DREW SMITH LIMITED

Site:-
SUMMER LANE PAGHAM

Drawing Title:-
HEADWALL CONSTRUCTION DETAILS

Drawing No. **DSM/E4761/441 D**

Headwall SW-1

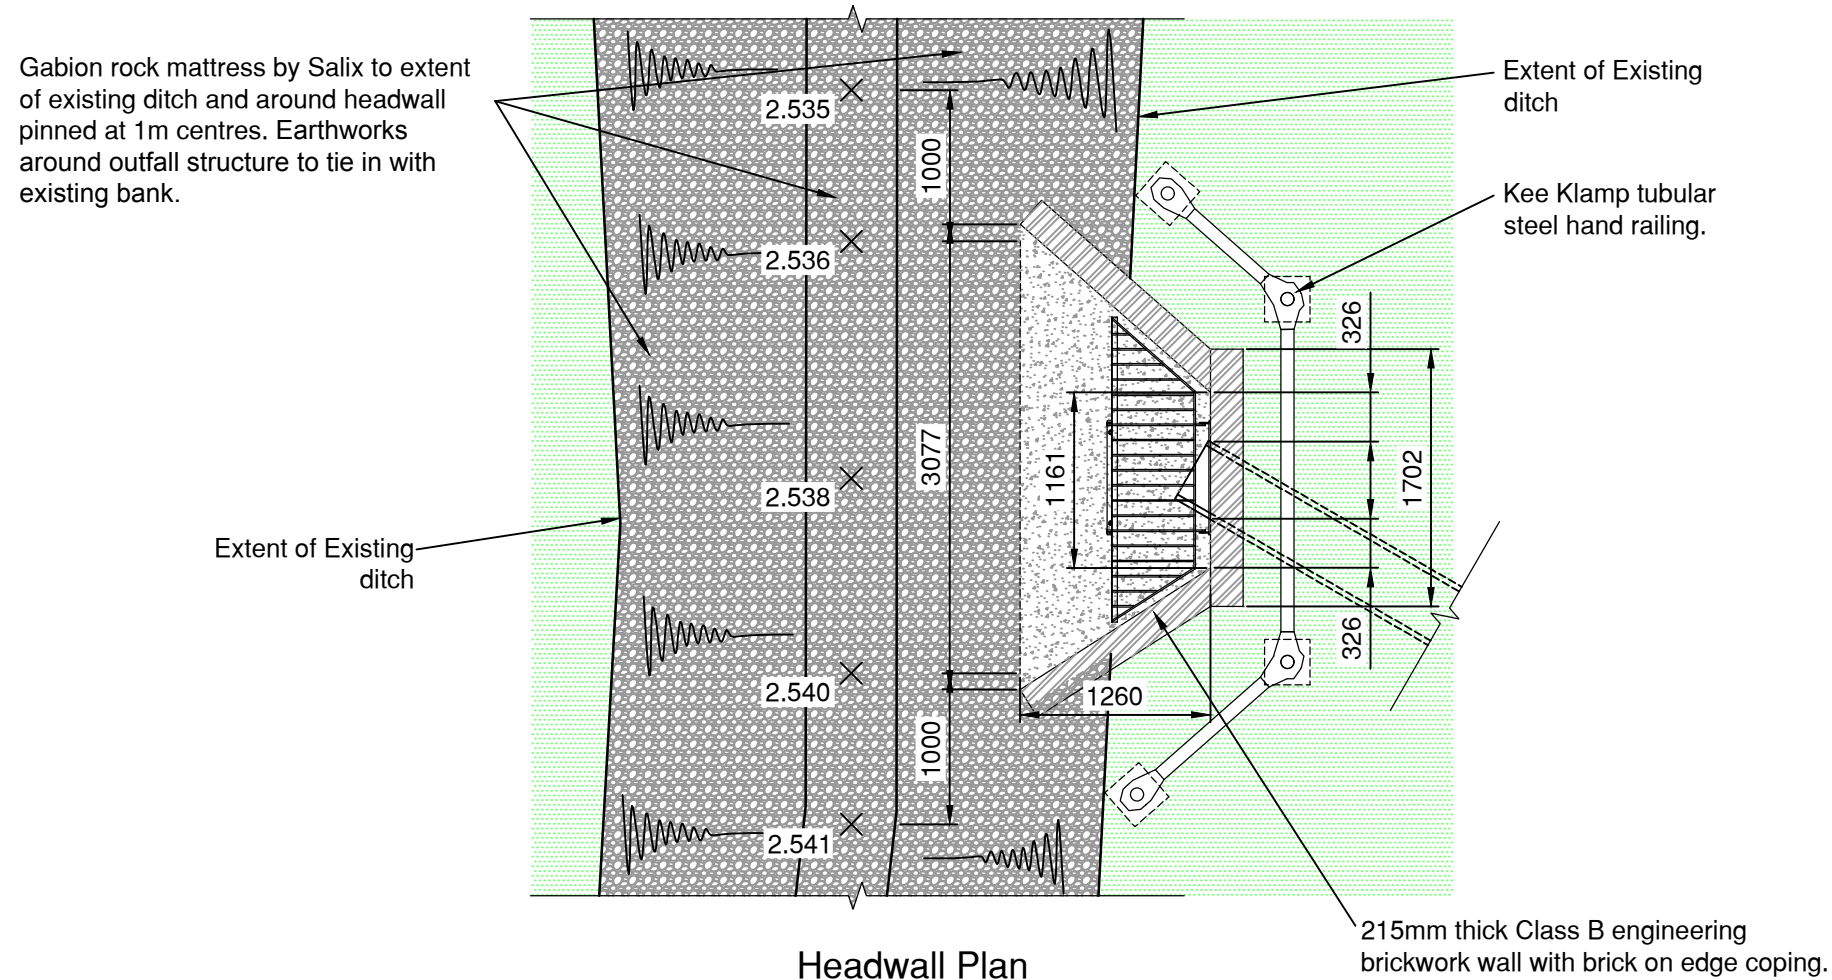
Rev.	Date	Details	By	Chkd	Appd
D	03.07.20	Headwall SW-1 incoming pipe and invert revised and grille added in accordance with drainage comments received from Arun District Council 23/06/2020. (Revision clouds omitted for clarity).	LD	TK	TRS
